RE: **Lot 11 Block 3 Unit 2 SAD 2287**
5605 Kimberlite Dr. NW
Grading and Drainage Plan
Engineers Stamp Date 5/7/2023 (E10D106)

Based upon the information provided in your submittal received 5/9/2023, this plan is approved for a revised Grading Permit.

ENGINEER'S SEAL 	Lot 11 Blk 3 Un 2 VC 5605 KIMBERLITE DRIVE	DRAWN BY DEM
	GRADING AND DRAINAGE PLAN	DATE 11-18-21
5/7/23	Rio Grande Engineering P.O. BOX 53284 ALBUQUERQUE, NM 87199 (505) 321-8099	SHEET # C1
DAVID SOULE P.E. #14522		JOB #

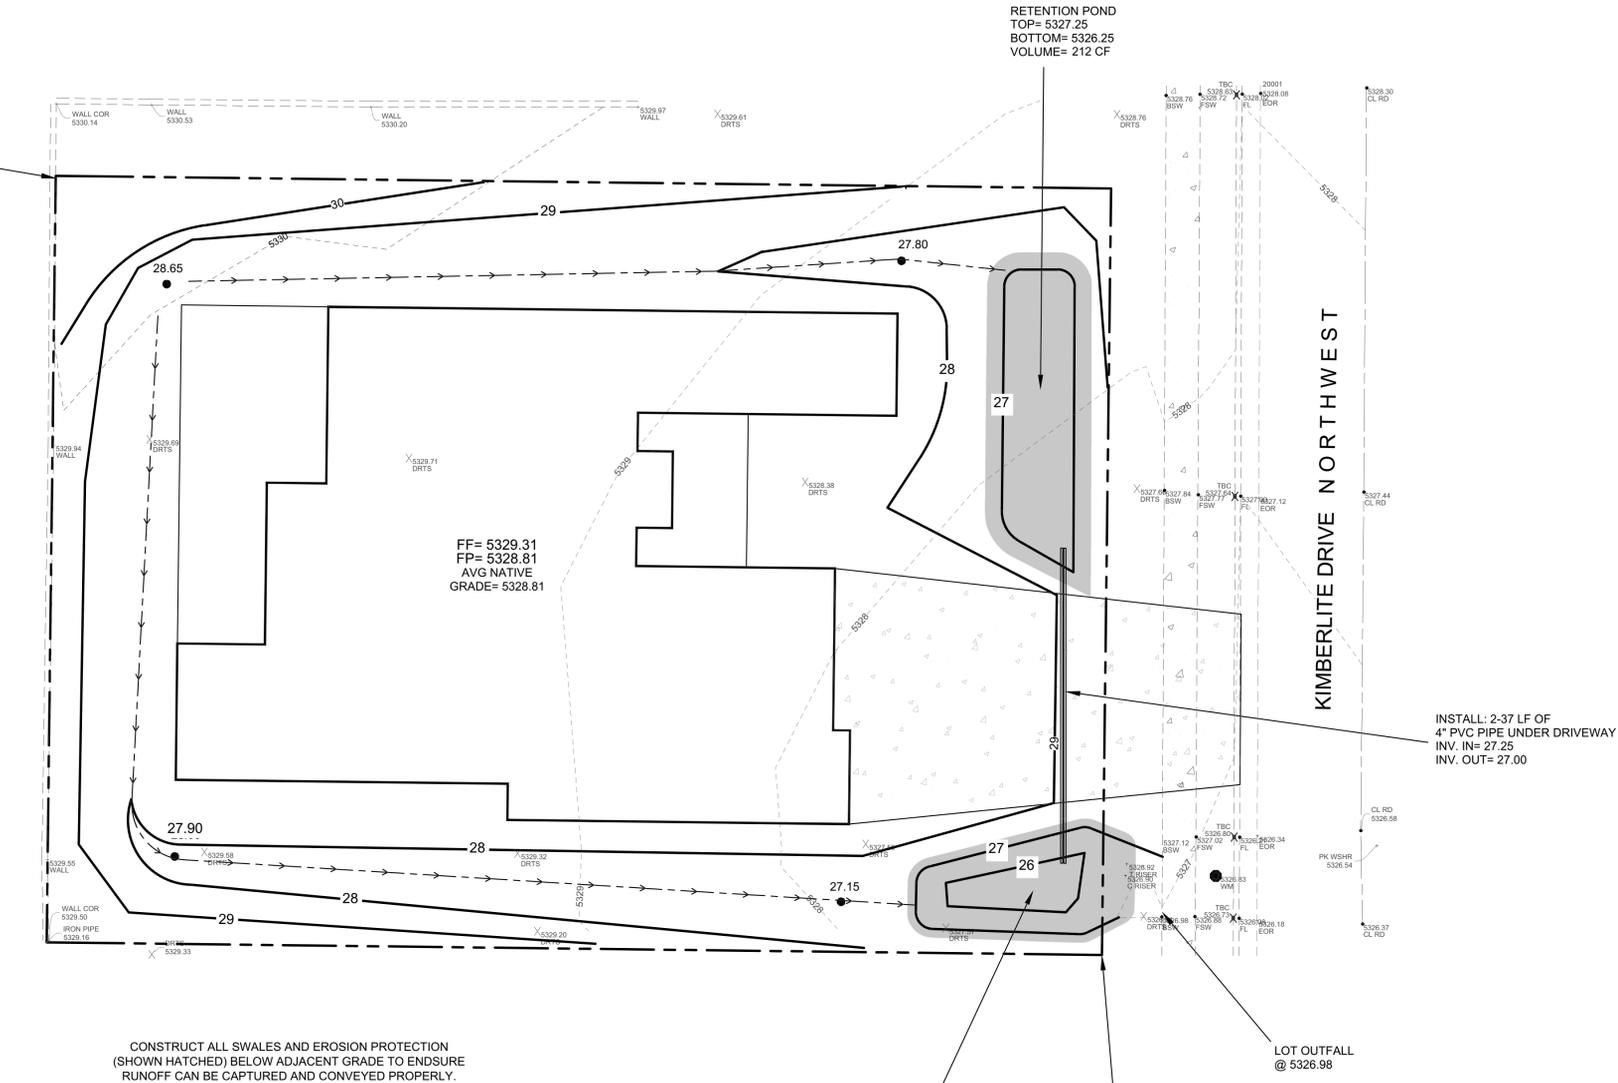
Prior to Building permit approval a Pad Certification will be required, provided by the Engineer or a registered Land Surveyor.

Advise the owner contractor not to use dirt as a ramp to climb the curb, use lumber or crusher fines for this purpose.

Reiterate to the Owner/Contractor that a separate permit for a garden/retaining wall must be obtained with the approved G&D plan and Pad Certification. Also, if a swimming pool is to be placed the grading and drainage plan will change and will need to be resubmitted.

Prior to Certificate of Occupancy release, Engineer Certification per the DPM checklist is required.
